CABINET MEMBER FOR ENVIRONMENT – 16 JANUARY 2020

DIDCOT – GREAT WESTERN PARK (SOUTHERN NEIGHBOURHOOD): PROPOSED 20MPH & 30MPH SPEED LIMITS

Report by Interim Director for Community Operations

Title
20 MPH ZONE GA SOUTHERN
SIGNAGE AND TRAFFIC CALMING

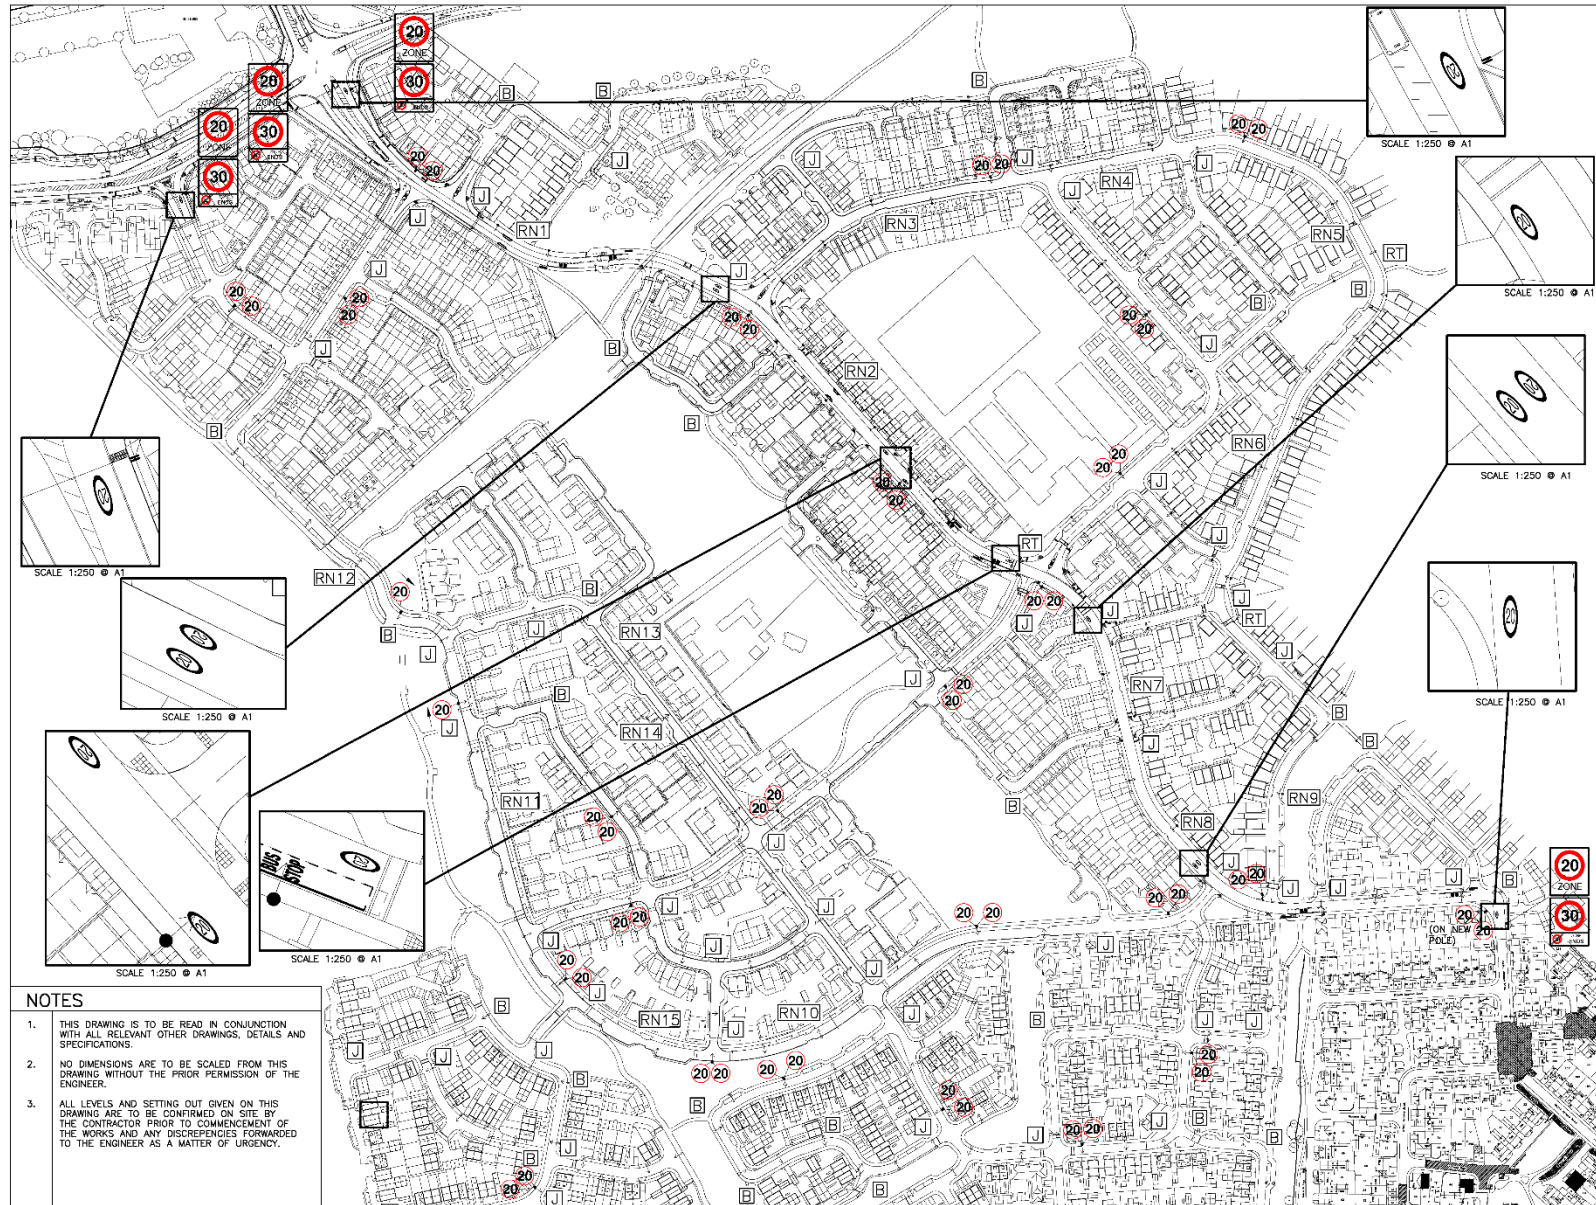
7. Thames Valley Police objected on the grounds that they do not consider that the zone as proposed will be self-enforcing in accordance with Department for Transport advice on 20mph speed limits and zones, taking account also the lack of speed surveys to inform their comments on this proposal.

9. Harwell Parish Council support the proposal.
10. The Oxford Bus Company on behalf of Thames Travel also support the proposal on the grounds of safety including for their passengers walking to and from bus stops. Their response did, however, raise a query on why Larch Drive (and the roads accessed off Larch Drive) were not included in the proposed 20mph zone.

RESPONDENT	SUMMARISED COMMENTS
(1) Traffic Management Officer, (Thames Valley Police)	<p>Object – The police stance still reflects that 20 mph limits and zones should still be self-enforcing. The policy of Thames Valley Police is to use sound practical and realistic criteria (Circular Roads 1/2013) when responding to Highway Authorities in an effort to promote consistency and to reduce the burden of constant and unnecessary enforcement.</p> <p>No speed data has been seen to support this speed limit proposals. One of the underlying principles of any new speed limit should be existing traffic speeds.</p> <p>I am aware this development already has some traffic calming measures, however during my site visit these appear to have little effect in terms of speed reduction with some features showing evidence of collision damage already. The 20 zone sign at the entrance also damaged. What will be consistent is the high level of abuse/compliant these proposals is likely to bring similar to the Northern site. Painting roundels on the road surface and a collection of upright repeater signs will not be a sufficient measure to achieve good compliance.</p> <p>As the key points in setting speed limits has been ignored, I object to the proposal relating to 20 mph pending further evidence that speeds are already compliant and that significant other engineering measures are included.</p>

(2) Harwell Parish Council	<p>Support – Harwell Parish Council supports the proposals outlined in the consultation.</p>
(3) Oxford Bus Company	<p>Support – On behalf of Thames Travel I am sure that our passengers will find the 20mph speed limit safer and more pleasant for crossing and walking along to join our services.</p> <p>On behalf of Thames Travel for the avoidance of doubt I would point out that as there is no difference in the type of development there is no logic to having the speed limit change at this point. The speed limit on Larch Drive and the estate roads to which it is linked would logically also be 20. I trust that there is a technical reason why the limit is set at 30 here.</p>

8. Noting the police response, the layout of the roads within the development are considered suitable for a 20mph zone taking account of their alignment which includes traffic calming features and, on the spine road, the use of 20mph roundels marked on the carriageway.

11. The response of Oxford Bus Company is noted and in respect of the query regarding Larch Drive, this was constructed by a different developer and so would require further funding to progress.
